Tanima Knit Composite Ltd. (Extension)

10/20, SOUTH DARIAPUR, SAVAR, DHAKA-1340
(23.833847, 90.254812)
10 October 2022

Buildings Information

Column Layout plan for ground floor to 1st floor

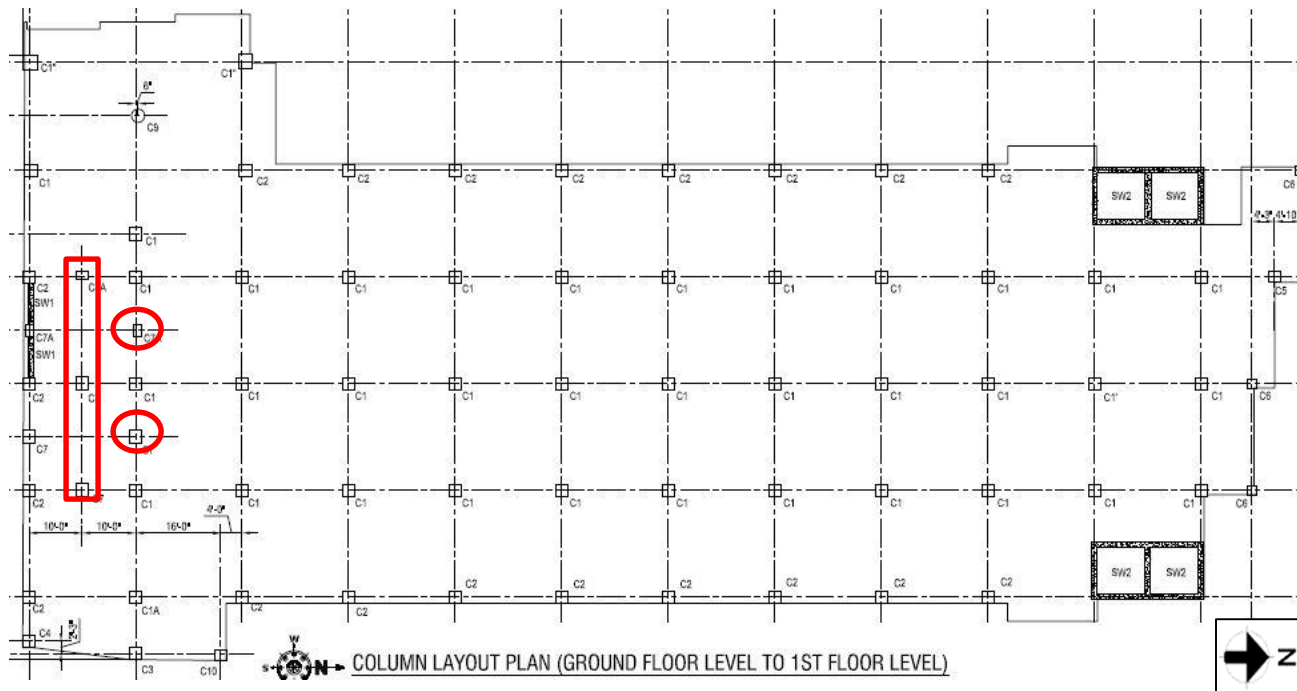
Marked columns were not found at ground floor to 1st floor level.

Toilet false slab and built-ups was not shown in drawings.

The building engineer is required to survey the structure and prepare accurate as-built drawings. Also, revise the structural analysis and EA report accordingly.

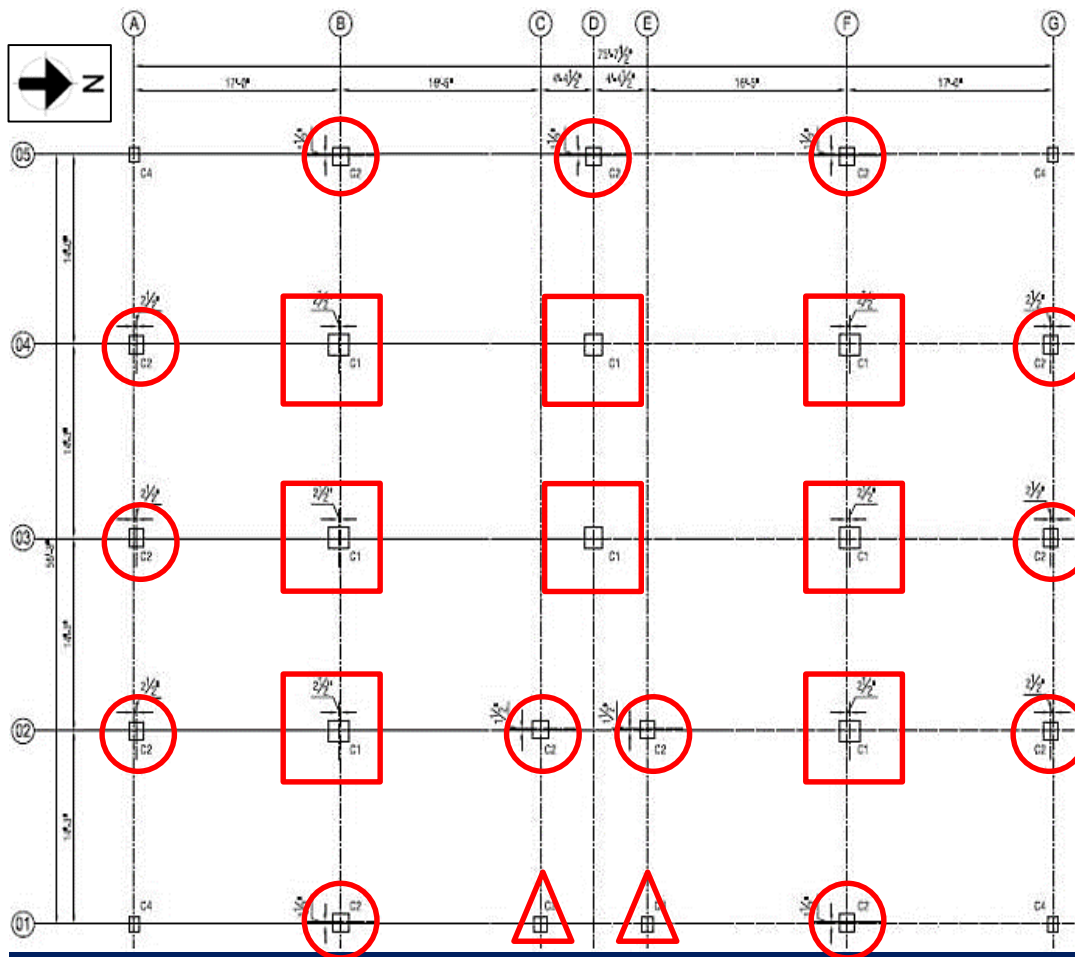
No load height marking on 2nd floor storage area

Storage in cutting table areas on 1st floor

Rack without lateral bracing or anchorage

The factory is required to implement floor load management program and maintain floor loading accordingly.

Provide lateral bracing or anchorage to all non-structural elements of the building.

Column Layout plan for Basement to GF

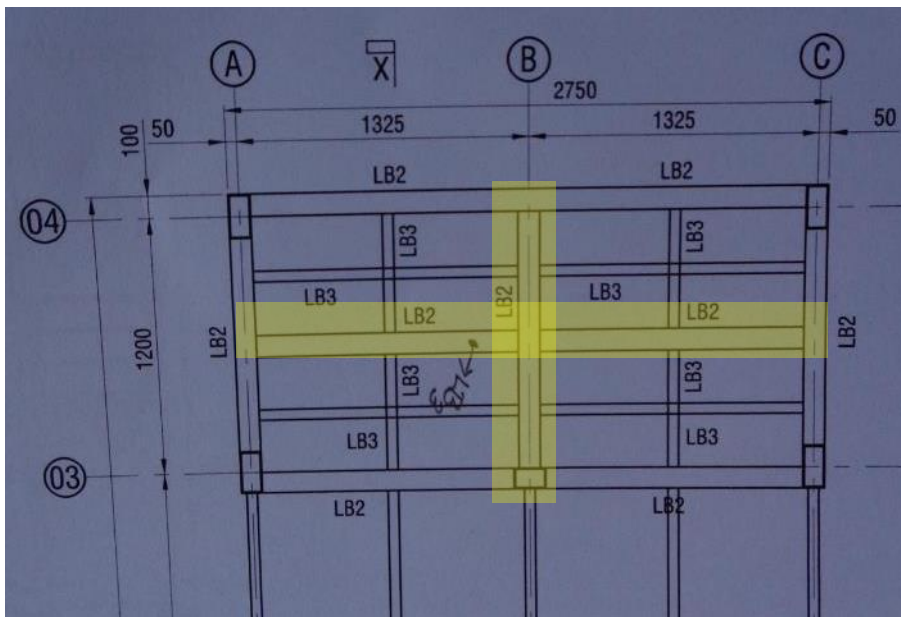
C1 column was found 800 mm X 800mm instead of 575mm X 525mm.

C2 column was found 700 mm X 700mm instead of 450mm X 450mm.

C3 column was found 600 mm X 600mm instead of 300mm X 300mm.

The building is required to survey the structure and prepare accurate as-built structural drawings.

Landing beam layout

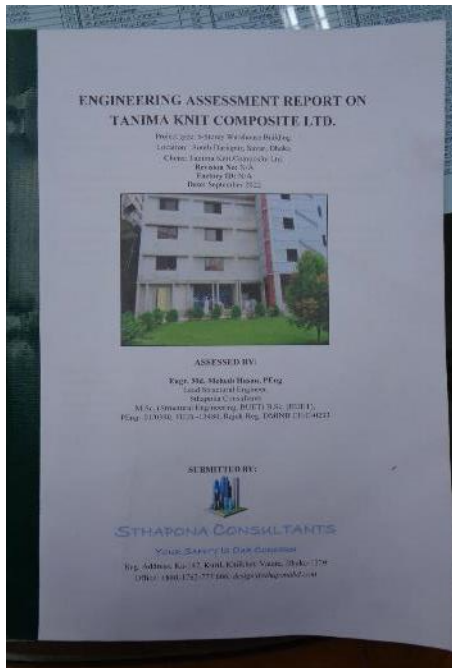
The middle beams of steel stair landing was mentioned as LB2 (100x100 mm box) but onsite the beam size was measured as 50x50 mm box (LB3).

The building is required to survey the structure and prepare accurate as-built structural drawings.

Building Information in the EA report

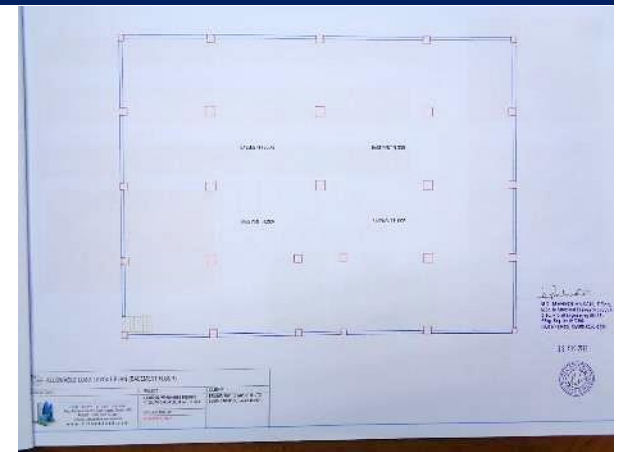
There are some mismatch between building information and onsite conditions. The flat plate framing system, basement floor and MAT foundation are not mentioned in the building information. Furthermore, construction year is mentioned as 2021 instead of 2006. Basement floor loading limit was not mentioned in the floor load plan.

Core test report from EA report

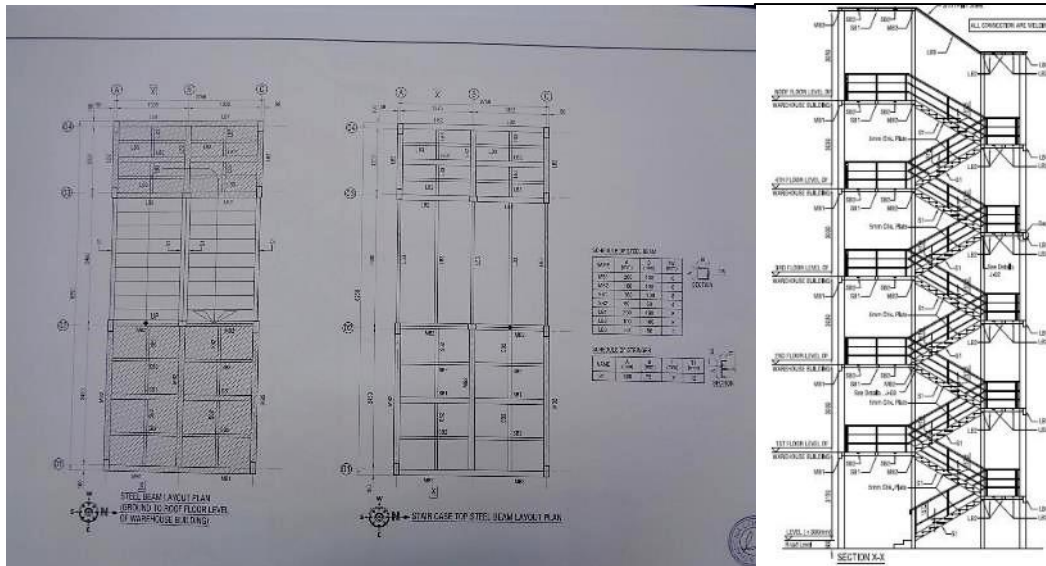
There are some mismatch between provided information of construction material and provided concrete core test report. As per EA report in general description the construction material was declared stone chips for foundation column, beam and slab but as per provided concrete core test aggregate types were shown brick chips. Building engineer is required to verify and confirmed the material type and material strength with correct material test report.

Retrofitting drawing of steel stair

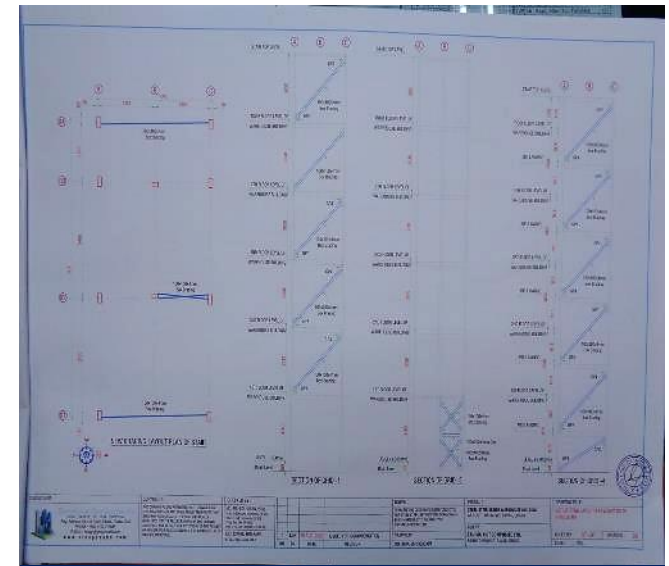
Retrofitting of steel stair was suggested in the EA report which has not been implemented yet. During inspection lateral support between RC building and steel stair was observed. The building engineer is required to investigate the support connections and revise connection details.

The building engineer is required to revise the EA report of both RC building and adjacent steel stair, and submit the revised EA to RSC for further review.
